ADA ASSESMENT REPORT
COMCARE – NORTHRIDGE FRIENDS CHURCH
2655 N. BULLINGER, WICHITA, KS
Report Date: August 5, 2008

The following ADA site assessment was performed on July 16, 2008 upon request of April Powell, Project Manager for Sedgwick County Project Services.

Figure 703.4.1 Height of Tactile Characters Above Finish Floor or Ground

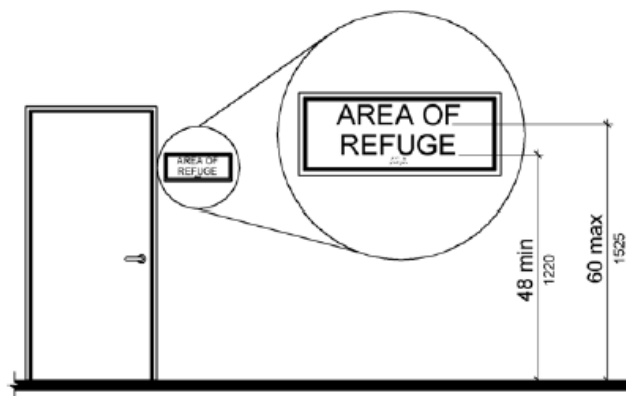
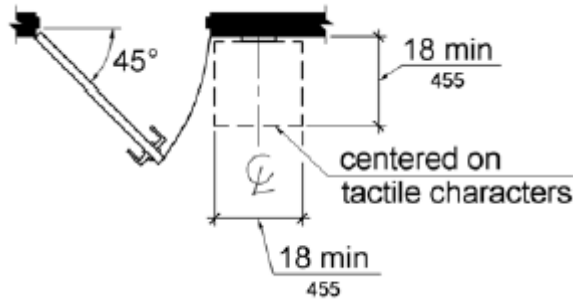
EXISTING CONDITION: Restroom signage is inappropriately located at both the Men's and Women's Restrooms. Signs that identify permanent rooms and spaces (room numbers, exit signs, and restrooms) are required to be provided in Braille, mounted at the latch side of doorway openings. The New ADAAG provides specific guidance on the location of signage. Tactile characters on signs are to be located 48 inches (1220 mm) minimum above the finish floor or ground surface, measured from the baseline of the lowest tactile character and 60 inches (1525 mm) maximum above the finish floor or ground surface, measured from the baseline of the highest tactile character. Where a tactile sign is provided at a door, the sign shall be located alongside the door at the latch side. Signs containing tactile characters shall be located so that a clear floor space of 18 inches (455 mm) minimum by 18 inches (455 mm) minimum, centered on the tactile characters, is provided beyond the arc of any door swing between the closed position and 45 degree open position. (ADAAG 4.1.3(16), 4.30 & New ADAAG 703)

Move signage so that it is located to comply with the new ADAAG. Mount signage so that it complies with the new ADAAG 703.4.1 and 703.4.2. Use the 60" maximum dimension to establish the mounting height.

Figure 604.5.1
Side Wall Grab Bar at Water Closets

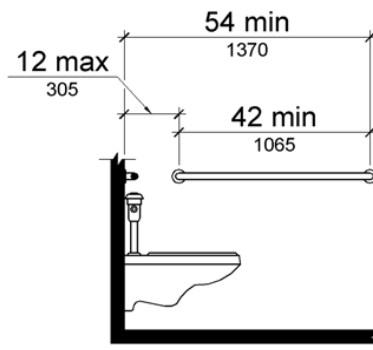
EXISTING CONDITION: The side grab bars at the Men’s and Women’s Restrooms comply with the current ADAAG (at 52”); however, the new ADAAG increases the side grab bar dimension from the back stall wall from 52” to 54” minimum. Per the new ADAAG, the side wall grab bar shall be 42 inches (1065 mm) long minimum, located 12 inches (305 mm) maximum from the rear wall and extending 54 inches (1370 mm) minimum from the rear wall.

Relocate grab bars at this time or immediately upon adoption of new ADAAG (Department of Justice is in its final review period, and imminent adoption is expected).
